# CITY OF TAMPA

## ADDENDUM NO. 2

Contract 13-C-00041; Howard F. Curren AWTP Methanol Feed Pump Replacement

G-1

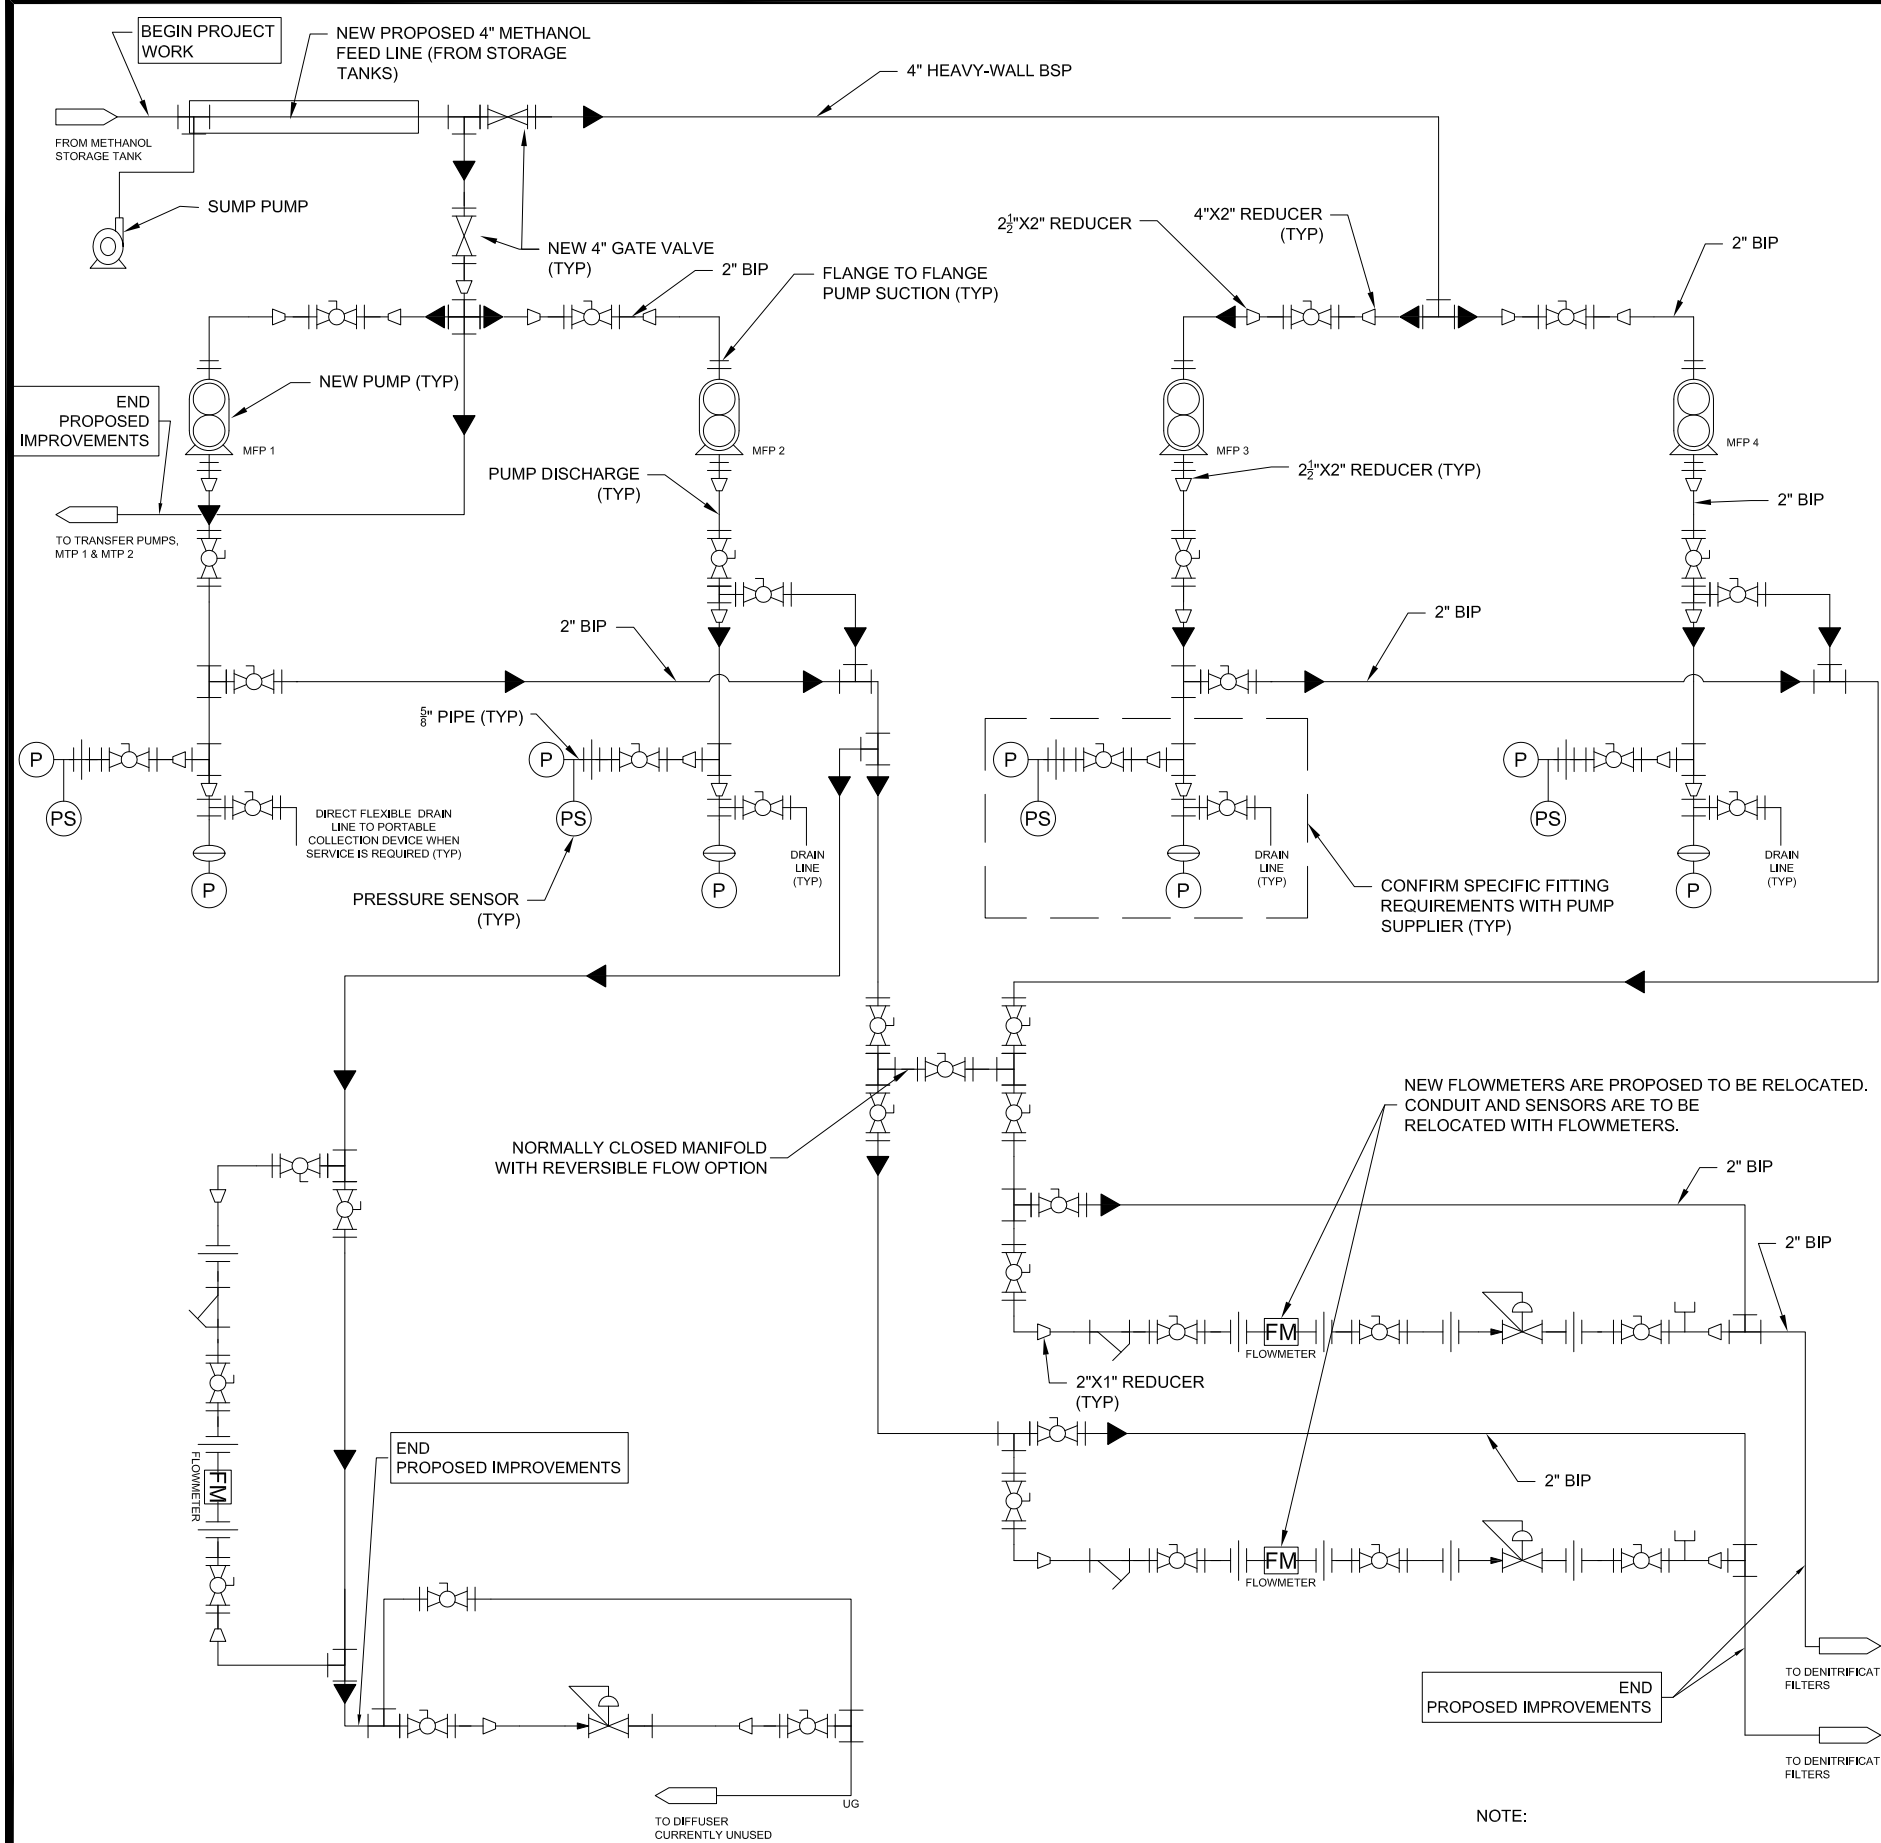
PROJECT WORK SUMMARY:

THIS PROJECT ENCOMPASSES THREE DIVISIONS OF WORK THAT INCLUDES CIVIL, MECHANICAL, AND ELECTRICAL TRADES. ALL PROJECT WORK WILL BE ACCOMPLISHED TO MAINTAIN UNINTERRUPTED METHANOL FEED OPERATIONS:

CIVIL: THIS WORK GENERALLY INCLUDES INSTALLATION OF NEW 4 INCH METHANOL TRANSFER AND FEED LINES (FROM THE EXISTING METHANOL STORAGE TANK CONTROL VALVES AND STRAINER TO THE IMPROVED METHANOL PUMP STATION), DEMOLITION AND RECONSTRUCTION OF THE AFFECTED FACILITY DRIVEWAY WITH NEW CONCRETE CURBING, CONCRETE PADS, AND OTHER MISCELLANEOUS POURED STRUCTURES. THE NEW METHANOL TRANSFER AND FEED LINES WILL BE INSTALLED IN A NEW TRAFFIC BEARING PIPE TRENCH AND GRATE AND A PRECAST SUMP AND ABOVE GRADE SELF-PRIMING SUMP PUMP WITH DISCHARGE PIPING DIRECTED TO THE EFFLUENT CHANNEL. THE CIVIL WORK ALSO INCLUDES IMPROVEMENTS IN BUILDING DRAINAGE WITH THE INSTALLATION OF NEW STORM GUTTER LINES ON THE PUMP STATION STRUCTURE, TO BE DIRECTED AWAY FROM THE BUILDING.

MECHANICAL: THIS WORK INCLUDES THE REMOVAL AND SALVAGE OF FOUR (4) EXISTING METHANOL PUMPS, FLOW METERS, AND RELATED EQUIPMENT AS NOTED ON THE PLANS, DEMOLITION AND REMOVAL OF EXISTING 2 INCH BLACK IRON PIPE AND APPURTENANCES, AND REPLACEMENT WITH FOUR (4) NEW PUMPS AND VALVES, PRESSURE SWITCHES, SPECIALTY PUMP PRESSURE CONTROLS AND EQUIPMENT. THE NEW EQUIPMENT WILL RECONFIGURED AND SUPPORTED WITH RELOCATED AND IMPROVED PIPE HANGERS AND PIPE SUPPORTS, STANCHIONS AND RELATED HARDWARE FOR THE NEW PIPING, VALVES, AND EQUIPMENT. ALL EXPOSED METALS WILL REQUIRE FIELD COATING AND ADDED COATING IN THE FIELD, AS SPECIFIED IN THE PLANS.

ELECTRICAL: THIS WORK WILL INCLUDE DEMOLITION OF THE EXISTING MOTOR CONTROL CENTER (MCC), INCLUDING THE CONTROL PANEL AND ANNUNCIATOR AND REMOVAL AND SALVAGE OF THE EXISTING GAS DETECTION EQUIPMENT. A NEW DOUBLE ENDED 480V MCC, 3 PHASE PANEL BOARD AND 480-120/208V, 3 PHASE TRANSFORMER TO SERVICE 120/208 V LOADS WILL BE INSTALLED IN PLACE OF THE FORMER MCC. A NEW METHANOL SYSTEM CONTROL PANEL WITH MAPLE TOUCHSCREEN GRAPHICS DISPLAY ANNUNCIATOR WILL BE INSTALLED. A NEW NEMA 4X ENCLOSURE WILL BE INSTALLED TO ENCLOSE THE EXISTING GAS DETECTION ANNUNCIATION EQUIPMENT. AN ADDITIONAL FEEDER CIRCUIT BREAKER IN EXISTING 'MCC 59" WILL BE PROVIDED TO THE NEW MCC (MCC59B) ALONG WITH TWO NEW FEEDER CIRCUITS.

1 REVISED NOTES FOR BID CLARIFICATION
